Case Number: C814-2012-0160
 Contact: Lee Heckman, 512-974-7604
 Public Hearing: Mar 12, 2013, Planning Commission
 Mar 28, 2013, City Council

As representatives of the owners of the above stated Property, we respectfully submit the enclosed Planned Unit Development ("PUD") application packages. The project is titled 211 South Lamar and is located at the southeast corner of South Lamar and Riverside. The PUD proposes a rezoning of the Property from CS, General Commercial Services, and CS-V, General Commercial Services – Vertical Mixed Use, zoning to PUD, Planned Unit Development District, zoning. The Property is currently developed as a Taco Cabana restaurant and surface parking lot. The owner intends to develop the Property with a mixed-use building.

As representatives of the owners of the above stated Property, we respectfully submit Update 1 to the Planned Unit Development ("PUD") application package. Included in this application package for your review is an updated Land Use Plan and superiority chart. Below please find the responses to comments from Reviewers:

ENV. TREE
 PUD EXHIBIT

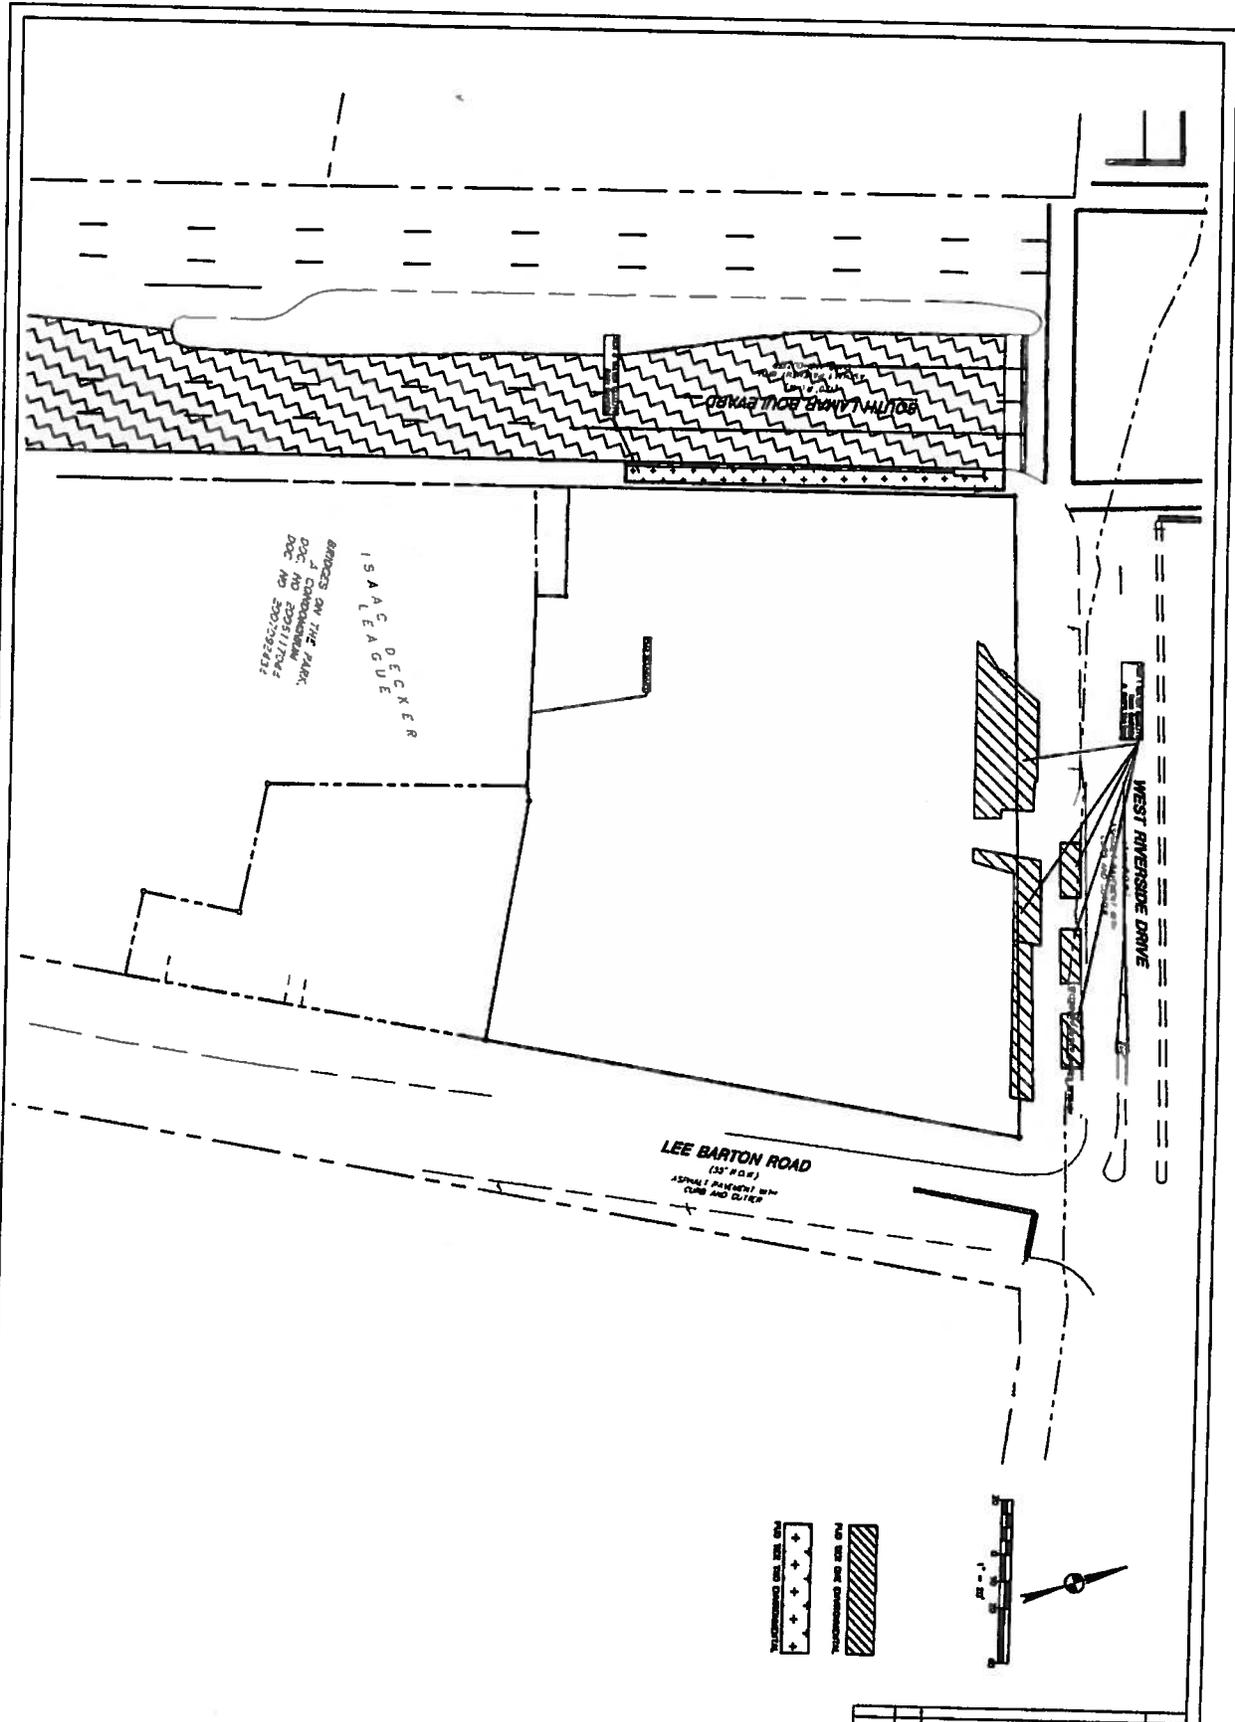
UPDATE #1 Note # 32 addresses the tree preservation criteria required to preserve trees in the PUD. The Env. Tree PUD Exhibit, sheet 4, shows tree #1709 to be removed in the list when it is supposed to remain, and it shows tree 1732 with a 50 ft CRZ instead of a 30 ft CRZ as stated in the tree survey list. Please correct these inconsistencies. This comment can be cleared informally.
